**RE: Lincoln Drive Median Access from Mockingbird Lane to the Eastern Town Limits**

Subject: Lincoln Drive, Mockingbird Lane to Town of Paradise Valley (TOPV) Jurisdiction  
Median Breaks and Access  
Third Party Traffic Review Comments

Kimley-Horn Comments on  
CivTech Access Assessment Option 1 through 3

Figure 4.2 Process for Selecting Average Rate or Equation  
in Trip Generation Manual Data

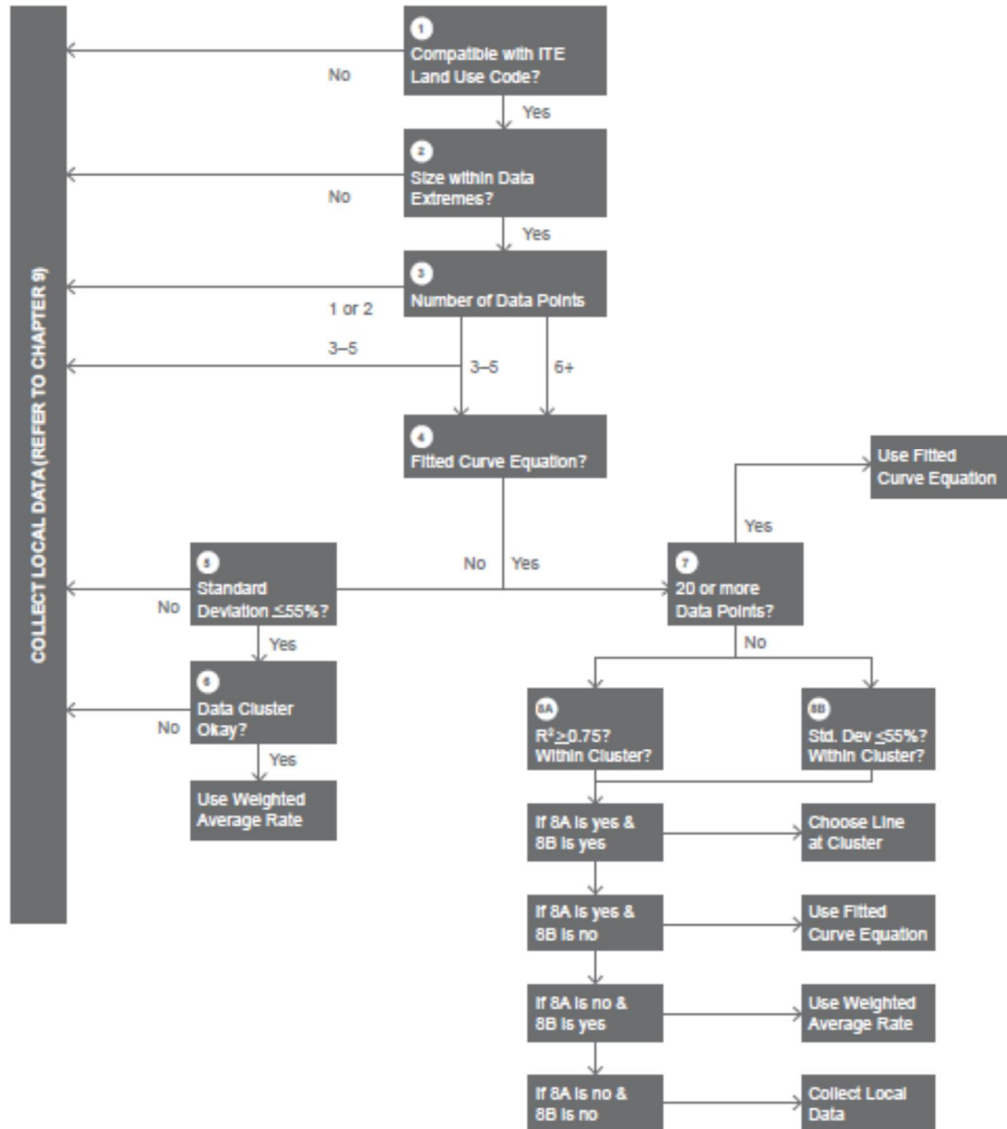
**KH Comments 4:** Smoke Tree Resort utilized equations as opposed to average rates. KHA went through the ITE Trip Generation Handbook process presented in Figure 4.2 assuming proposed number of units for resort hotel (LUC 330). The results of this process are presented below and KH redlines provided in **Appendix 1**.

**Response to Comment 4:** CivTech has updated the trip generation rates to reflect a blended rate between LUC 310 and 330 as discussed in response to comment #3. The trip generation calculations were also revised to reflect 150 rooms, 30 residential units, and 3500 square foot quality restaurant. The revised trip generation calculations and approach were considered acceptable. The revised trip generation calculations, based on 150 rooms, 30 residential units, and 3500 square foot quality restaurant, are provided in **Appendix 2**.

## Resort Hotel (330)

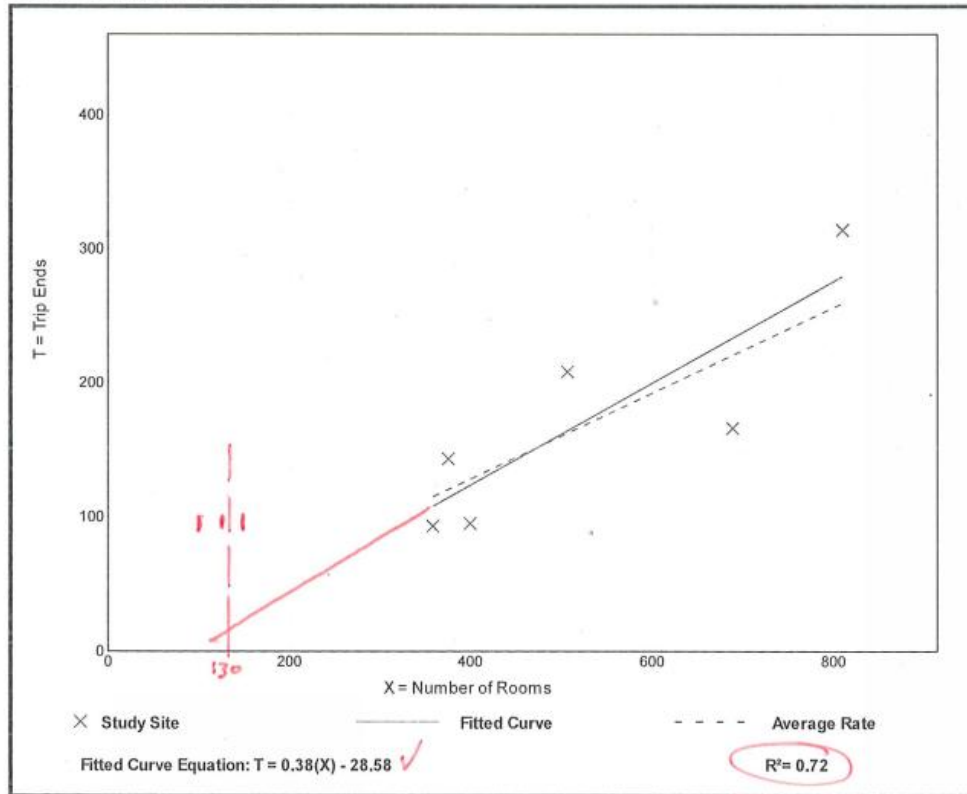
#### Resort hotel (LUC 330) AM peak hour between 7-9am

- The number of rooms is way out of range of the data extremes; the lowest number of rooms in the manual is roughly 370 compared to the 132 that are proposed
- If you follow the equation, which happens to be a straight line and not a logarithmic function, then 132 rooms will generate a very low number of trips
- The number of data points is equal to 6
- The R2 value is close to the required 0.75, so you could argue it either way
- The standard deviation is less than 55% of the average rate

Because the rooms are not within the data extremes and the R2 value is less than 0.75, we recommend the weighted rates be used. Using the rates as opposed to the equation results in double the trips being generated in the AM peak hour.

## Resort Hotel (330)

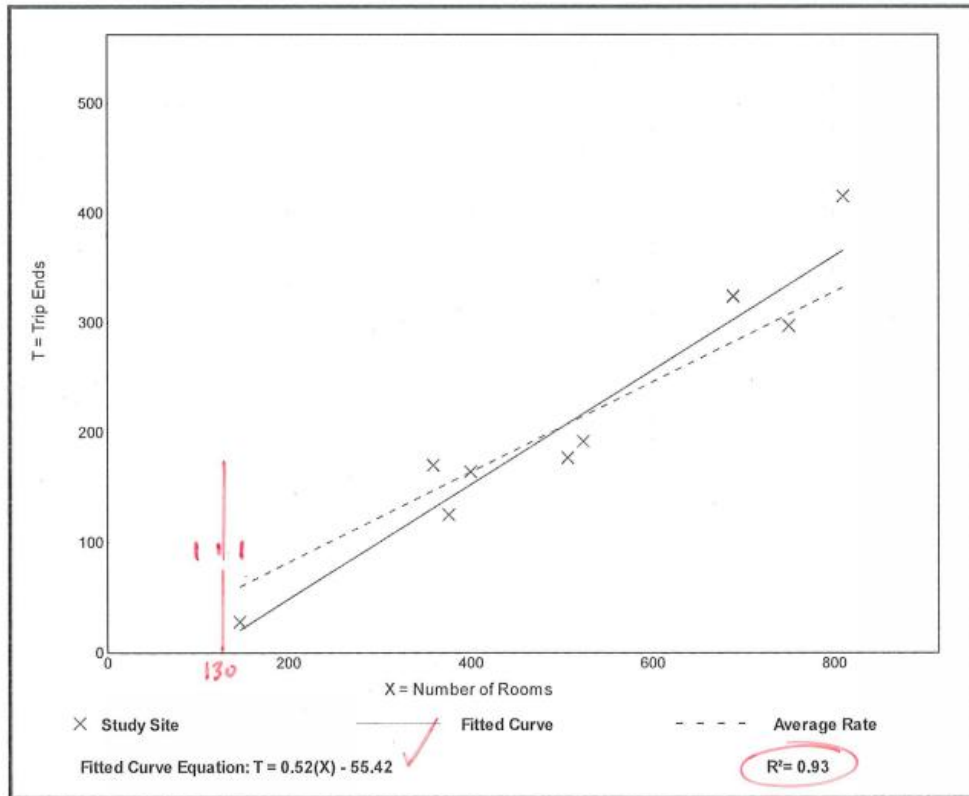
#### Resort hotel PM peak hour between 4-6pm

- The number of rooms is just outside of the data extremes
- The number of data points is greater than 6
- The R2 value is well above the required 0.75
- The standard deviation is less than 55% of the average rate

Because the number of data points and the R2 value are high enough and the standard deviation requirement is met, the use of the equation during the PM peak is appropriate.

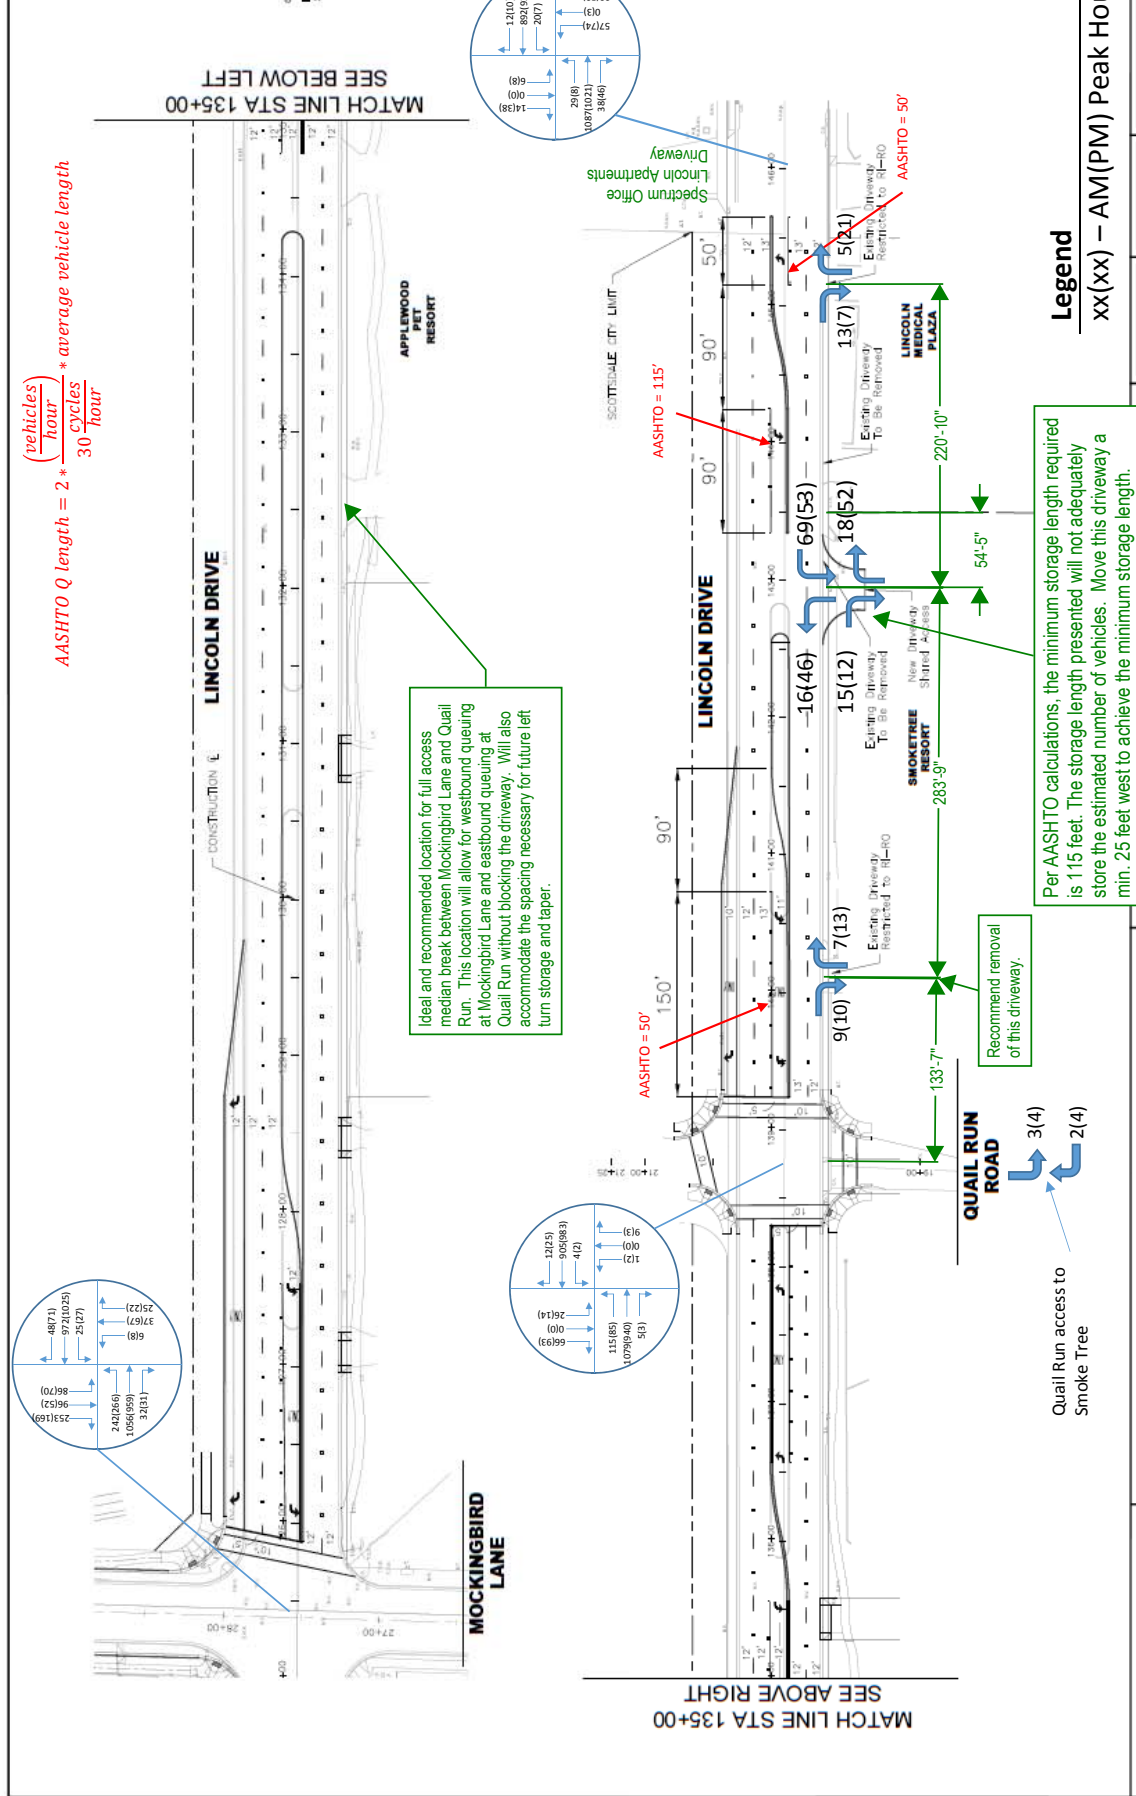
**KH Comment 11:** As shown in Option #1 exhibit, access improvements include closure of the existing eastern access on Smoke Tree Resort, a new Smoke Tree Resort access approximately 183 feet west of Lincoln Medical Plaza access, and the existing Smoke Tree Resort western access to remain as right in/right out. The proposed improvements result in the following spacing (centerline to centerline) of driveways:

**KH Comment 12:** The storage length shown in Option #1 exhibit for Lincoln Medical Plaza is 70 feet. Per AASHTO calculations, storage length should be no less than 70 feet to adequately store the estimated number of vehicles generated by Lincoln Medical Plaza. This is considered acceptable. The storage length for the Smoke Tree Resort eastern driveway is 75 feet. Per AASHTO calculations, storage length should be no less than 55 feet to adequately store the estimated number of vehicles generated by the Smoke Tree Resort. This is considered acceptable.

**KH Comment 13:** As shown in Option 1 exhibit prepared by CivTech, opening bay tapers are 40 feet at Smoke Tree Resort and 43-3” feet at Lincoln Medical Plaza. KH recommends that no less than a 90-foot opening taper be utilized to safely traverse traffic from the through lane to the left turn lane on Lincoln Drive, per the criteria and discussion on Page 4, 5, and 6 of this document. Kimley-Horn recommends the median be extended and access points to Lincoln Medical Plaza be restricted to right in/right out only movements for two reasons:

Based on the results, Kimley-Horn recommends the western Smoke Tree Resort driveway be closed to achieve the minimum spacing from Quail Run.

**SHEET**  
Opt-03  
03 OF 03

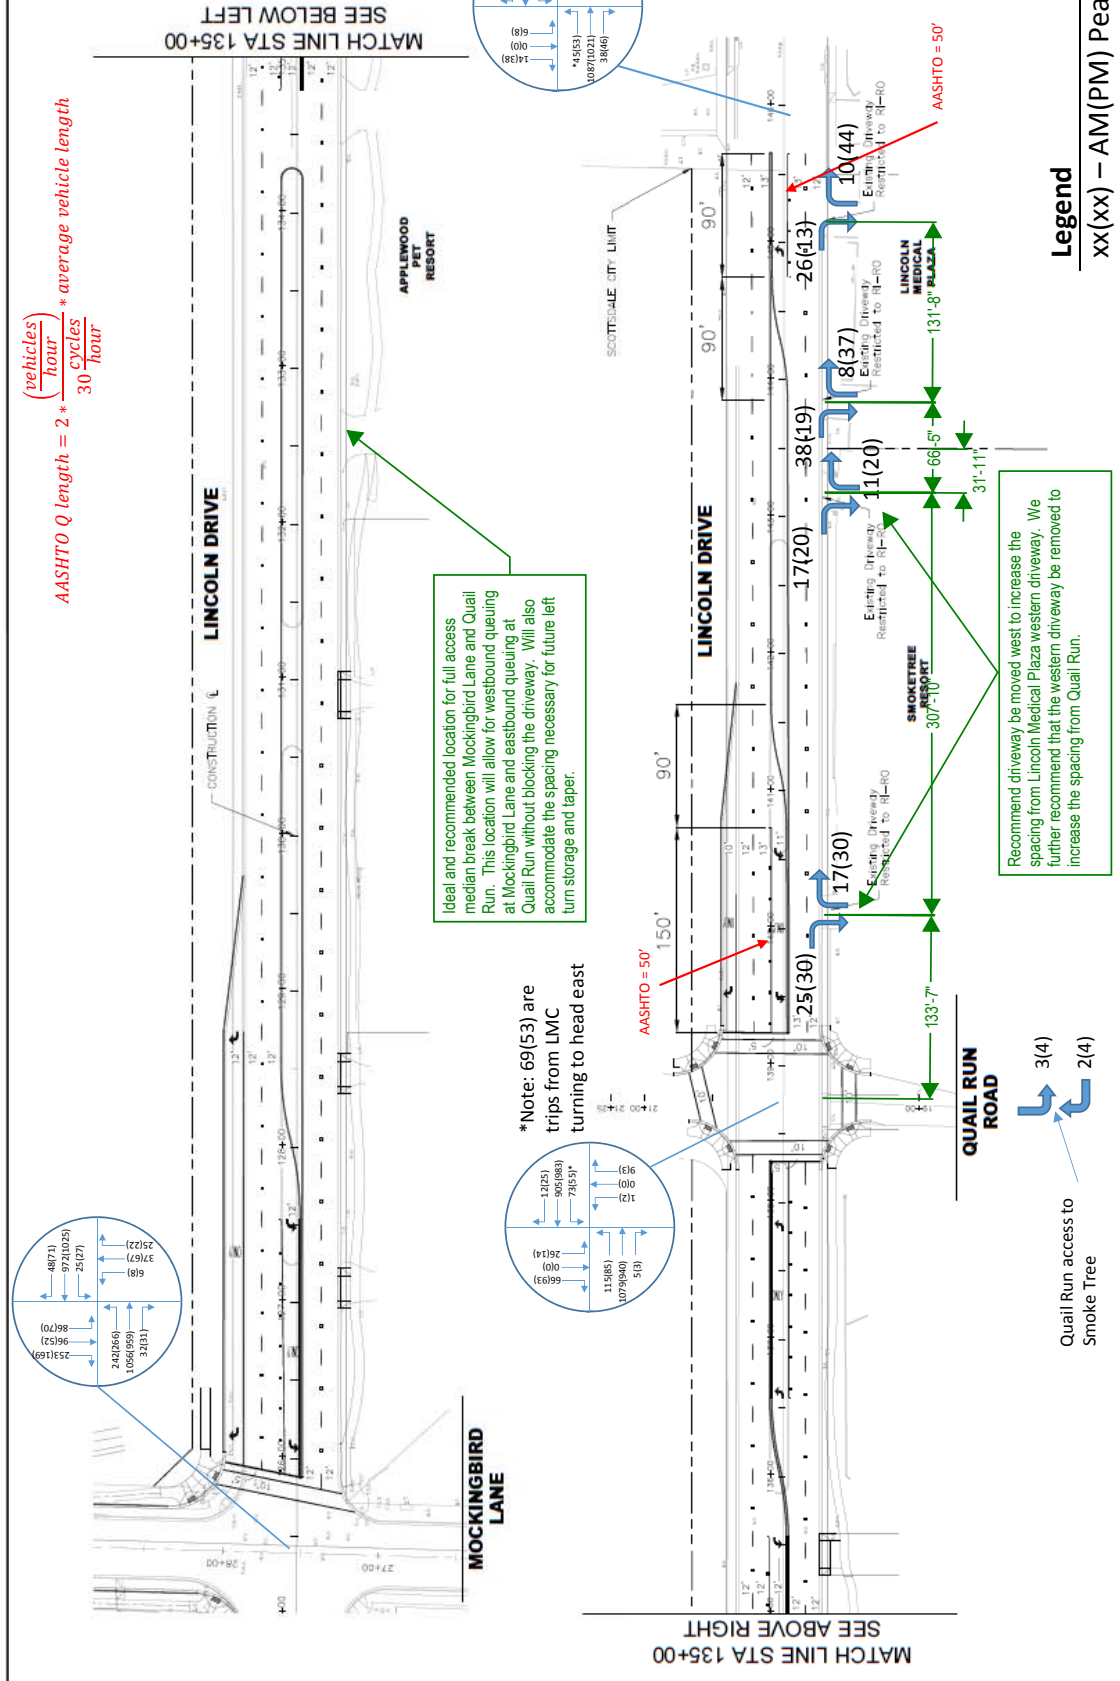
**KH Comment 17:** *As shown in Option #3 exhibit, all existing driveways between Quail Run and eastern Lincoln Medical Plaza access points, will remain and be restricted to right in/right out only. This results in the following spacing (centerline to centerline) between the existing driveways:*

*Per City of Scottsdale Design Standards & Policy Manual (2018), the minimum driveway spacing is presented the minimum spacing required (250 feet) on Lincoln Drive. Kimley-Horn recommends the western Smoke Tree Resort driveway be closed to achieve the minimum spacing from Quail Run. We further recommend that with the improvements to both Smoke Tree Resort and Lincoln Medical Plaza that the driveways be improved to achieve the minimum spacing.*

**KH Comment 18:** *This option does provide the safest option by removing the conflict points that would occur with left in/left out maneuvers. It should be noted that Lincoln Drive does not provide enough pavement width necessary to safely make U-turn maneuvers. Providing an access point that is located to safely transition and adequately store the estimated left turn volumes will reduce the need for U-turn maneuvers. Allowing shared access between the Smoke Tree Resort and Lincoln Medical Plaza parcels would remove the need for any U-turn maneuvers. For this option, should it be determined that shared access will not be provided, Kimley-Horn recommends U-turns be restricted.*
